Addendum No. 3
Four Rivers Sanitation Authority
Collection Systems Operations Facility
Capital Project No. 2217

This Addendum No. 3, dated February 14, 2023, for the above referenced project, supersedes all contrary and conflicting information in the specifications and contract documents, which are hereby supplemented or revised as follows:

New Collection
Systems Operation
Facility

Ref. North Sheet No.
E102

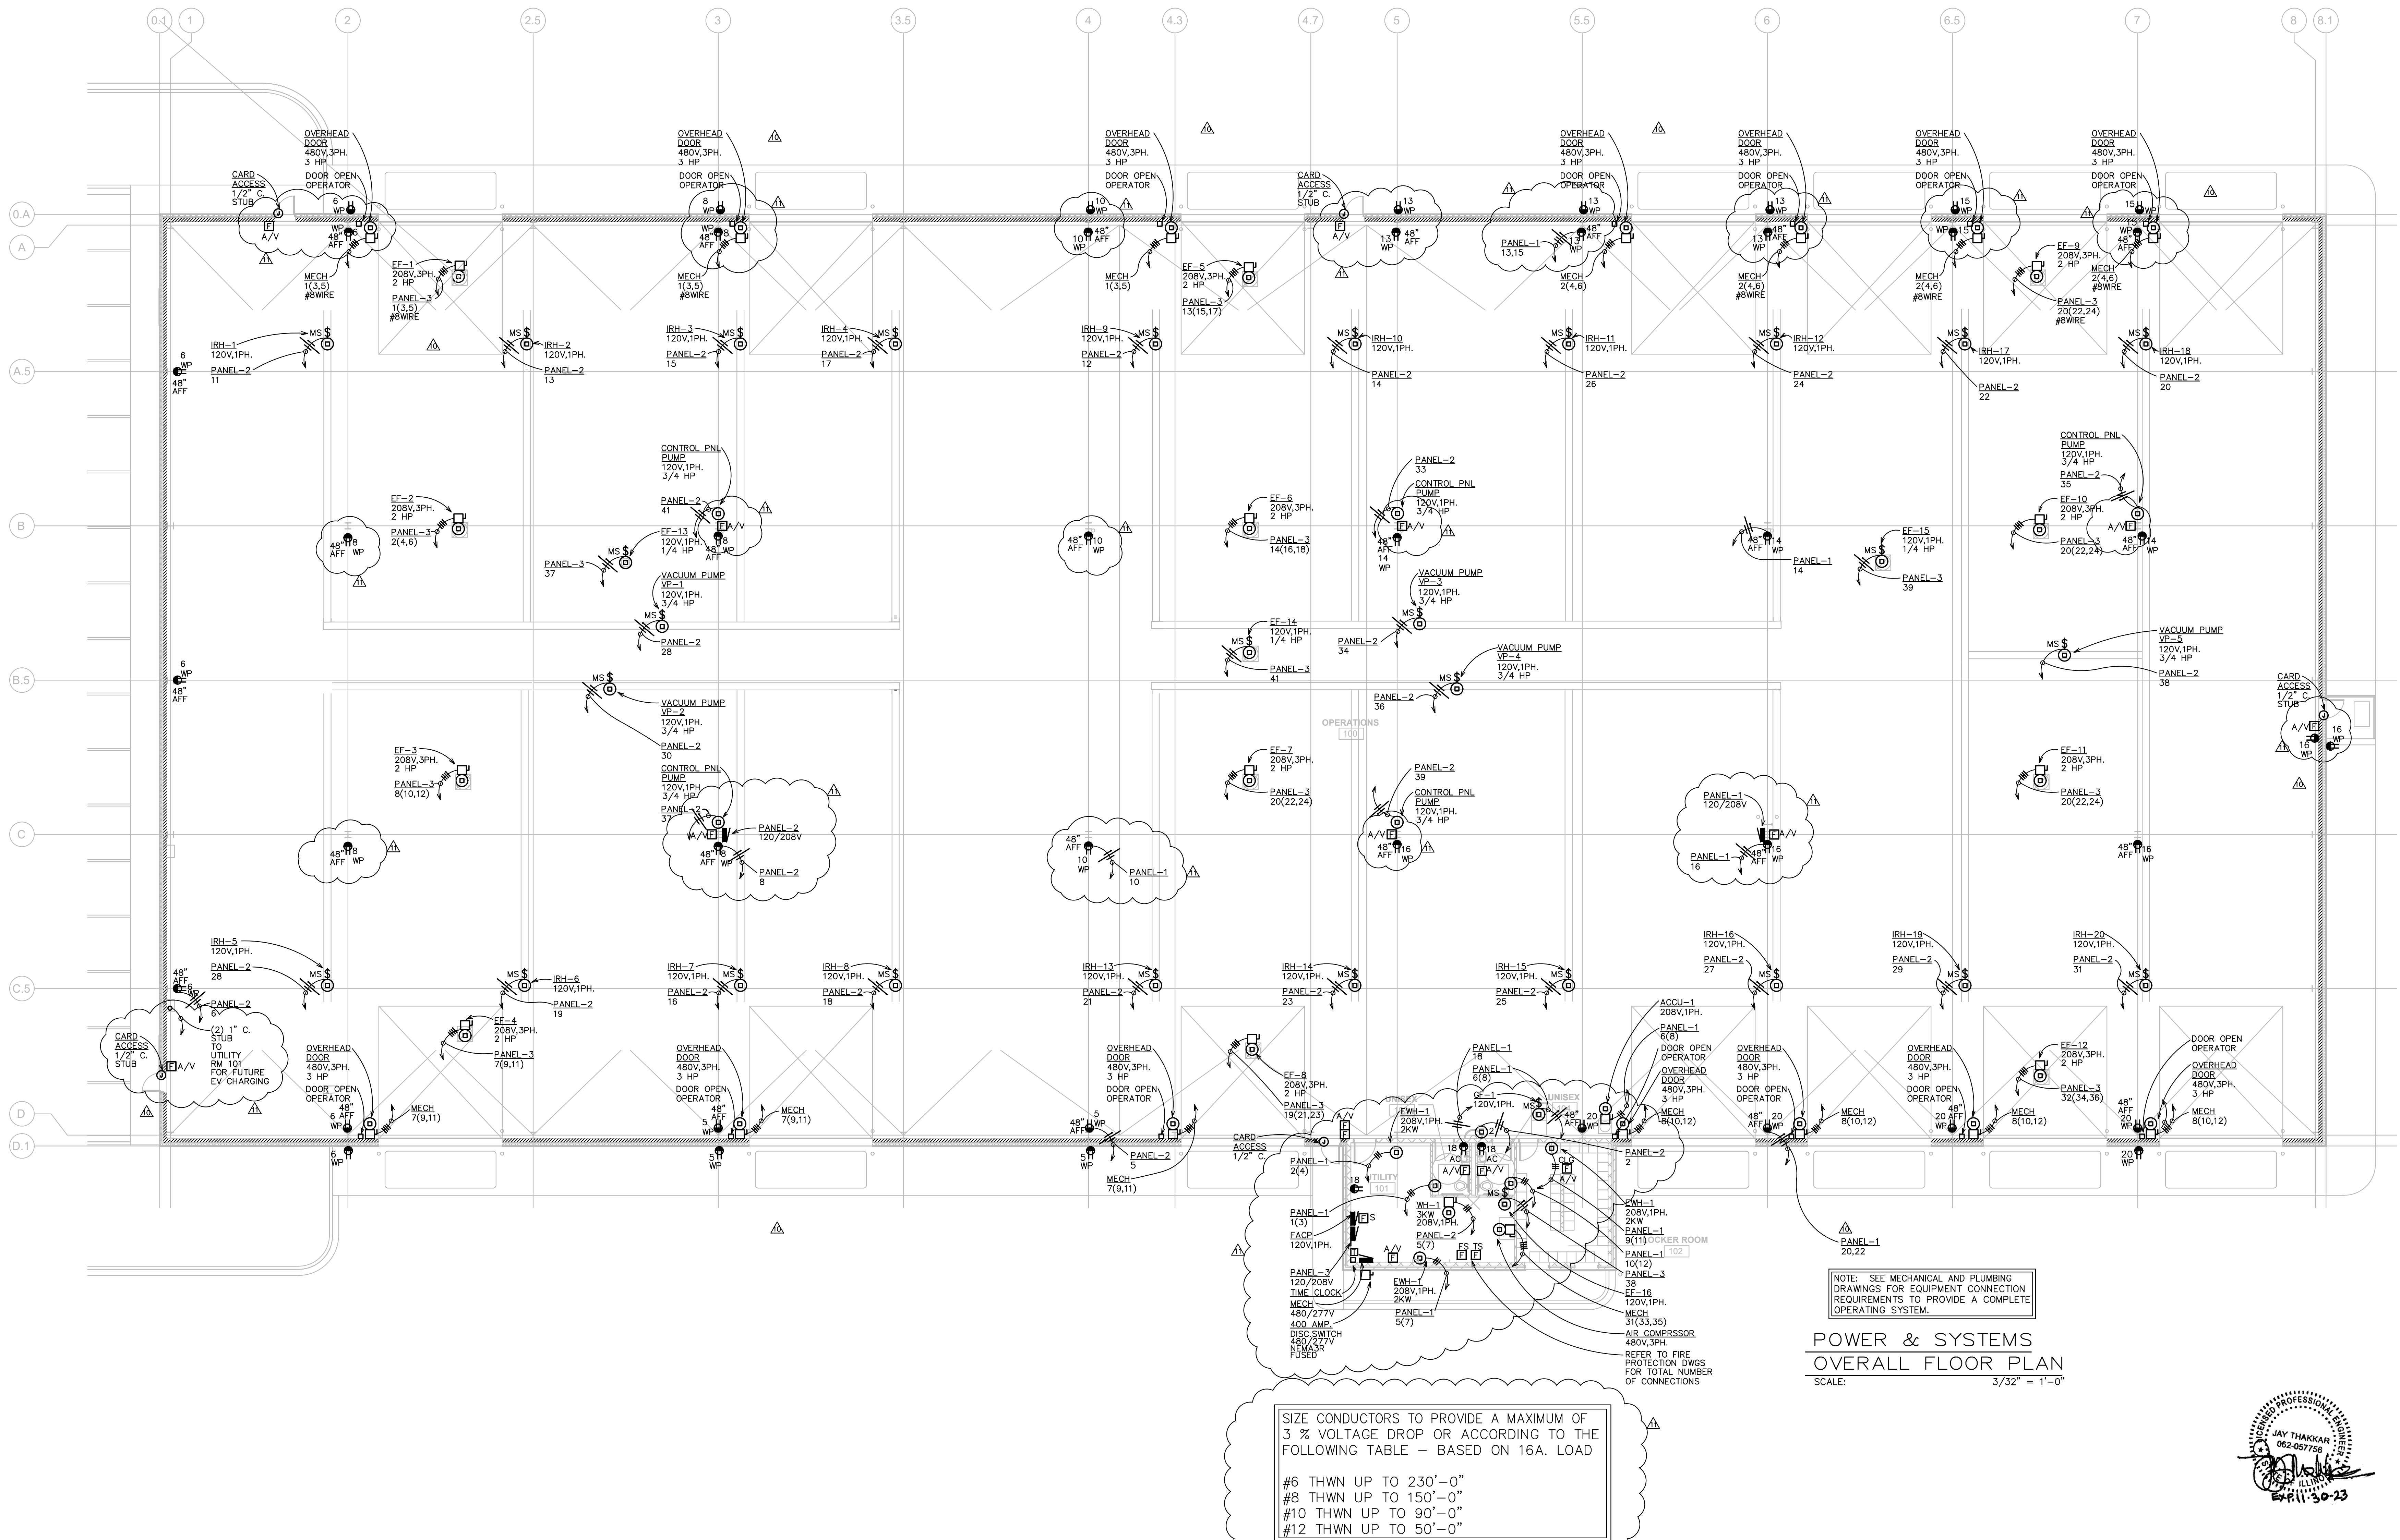
1. Typically, horn strobes for the fire alarm system cover a 50'x50' area (2,500 SF) maximum. The horn strobe coverage shown on the drawings is much less than this. Can the engineer review and determine if additional horn strobe coverage is needed?

Response: *Reference revised Plan Sheet E102 for revisions to the fire alarm system.*

Ref. North
Sheet No.
P101

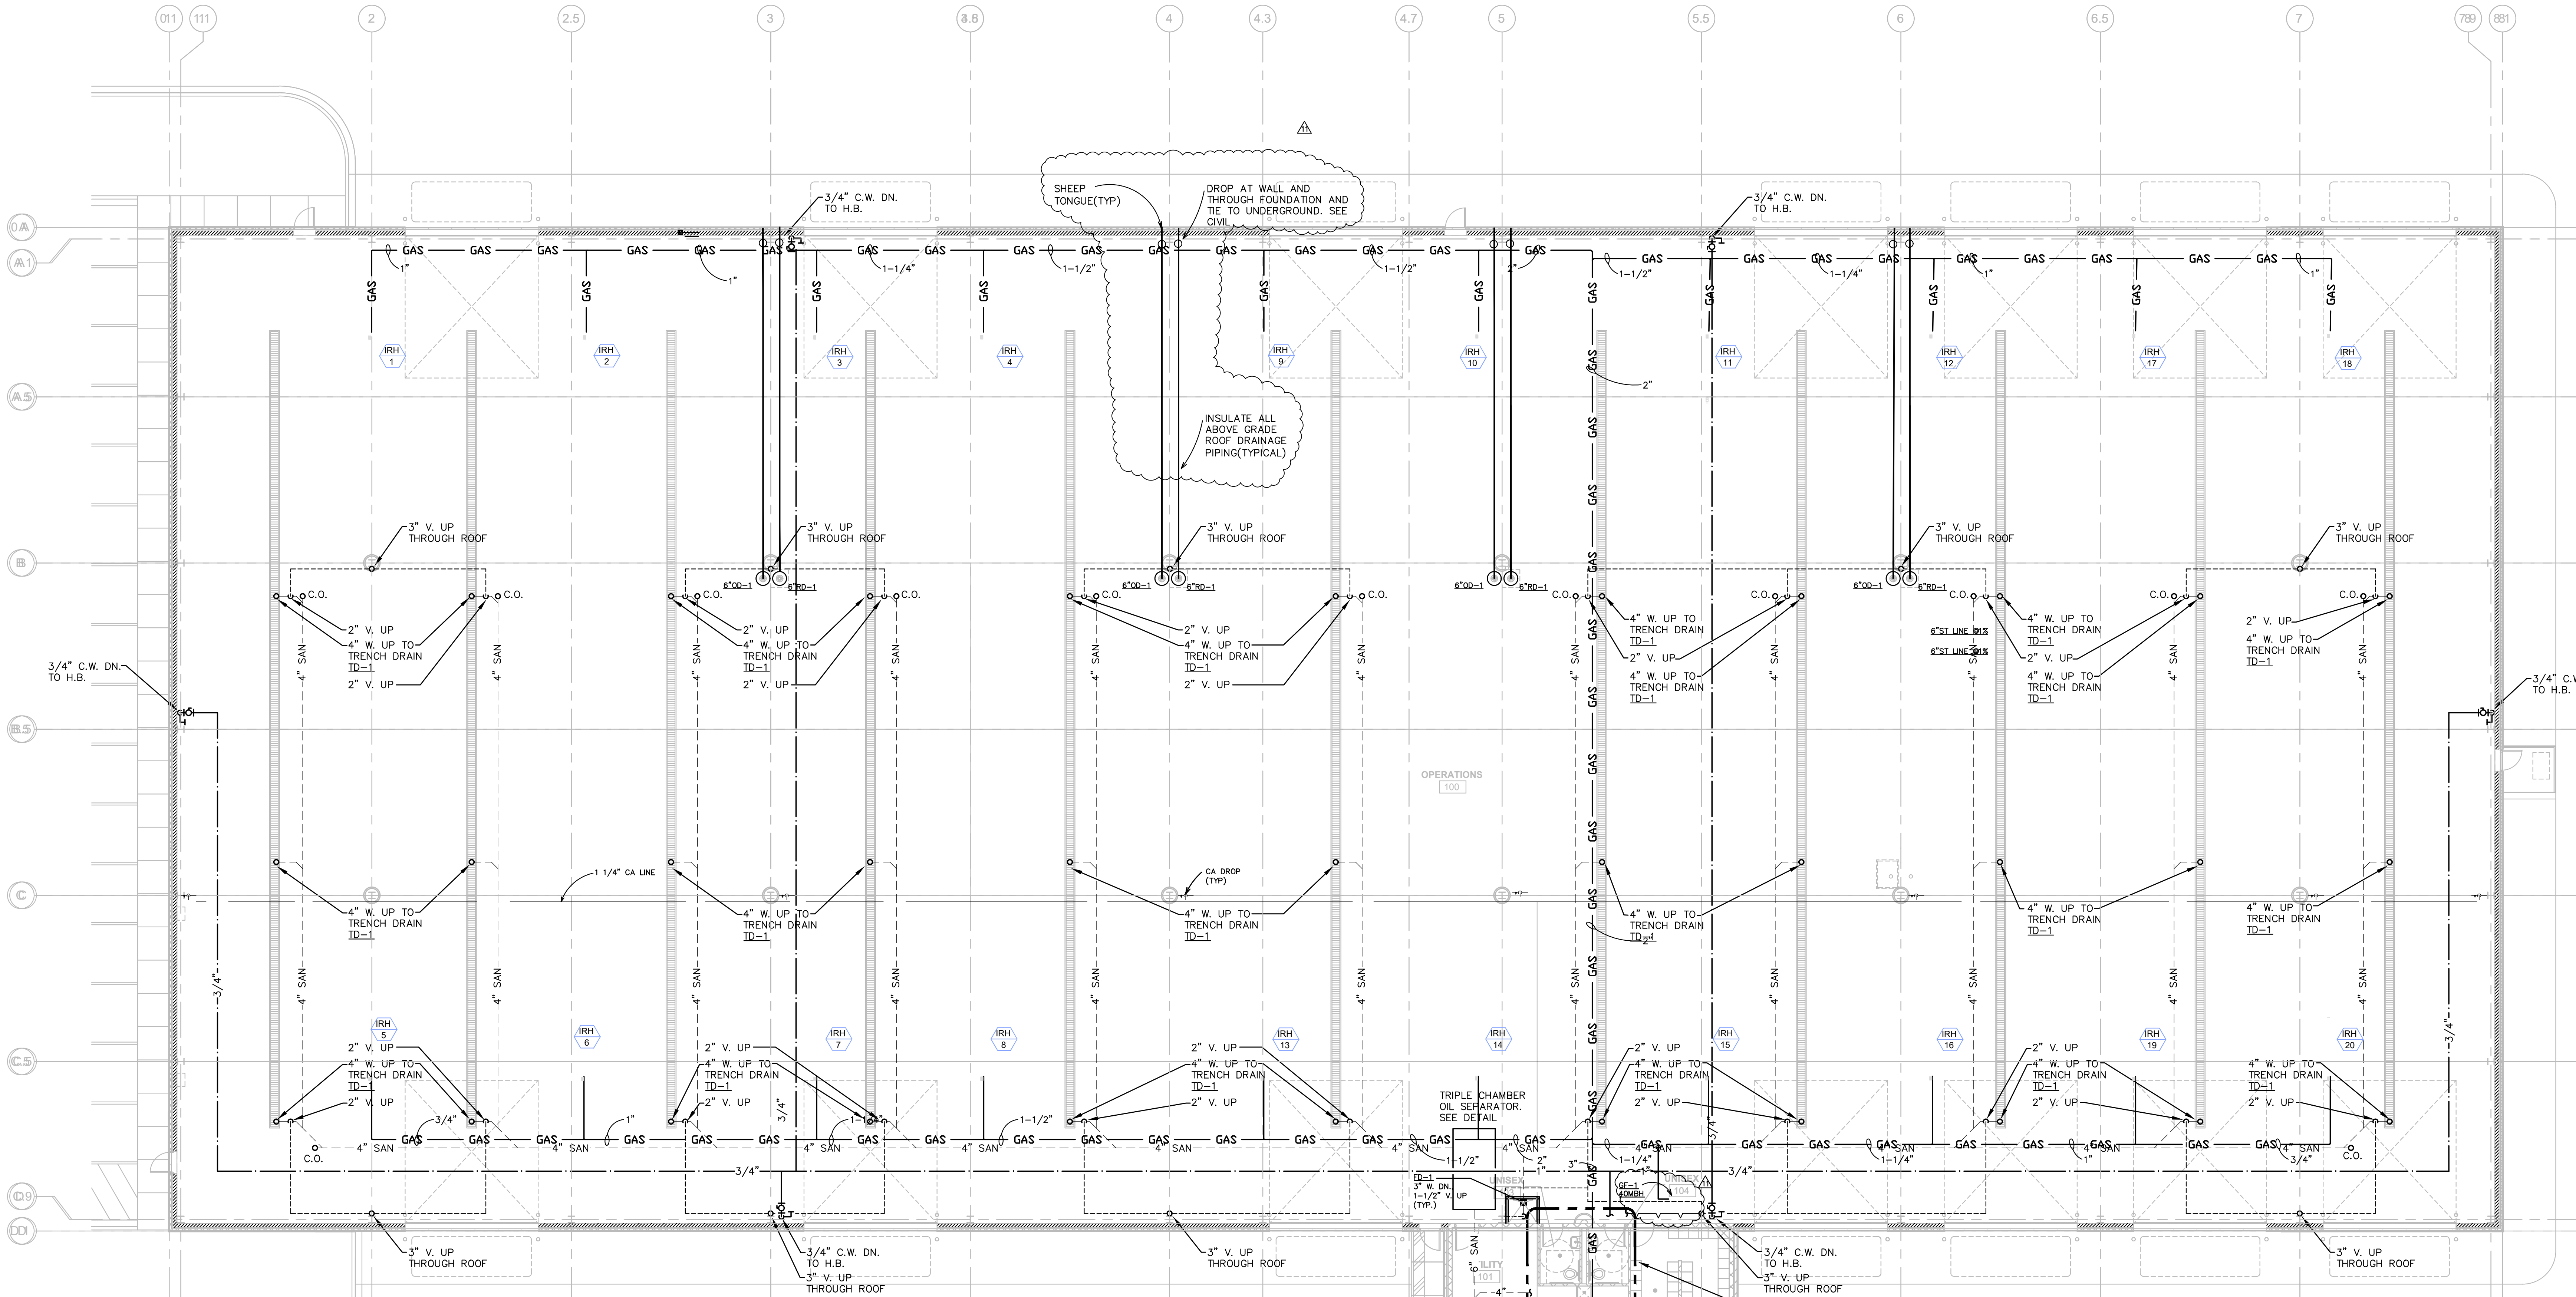
37. Is the overhang roof drain and bump out roof drain tied together inside the building and then exit as a 10"?

Response: *Reference revised Plan Sheets P101 and P102 for clarification.*
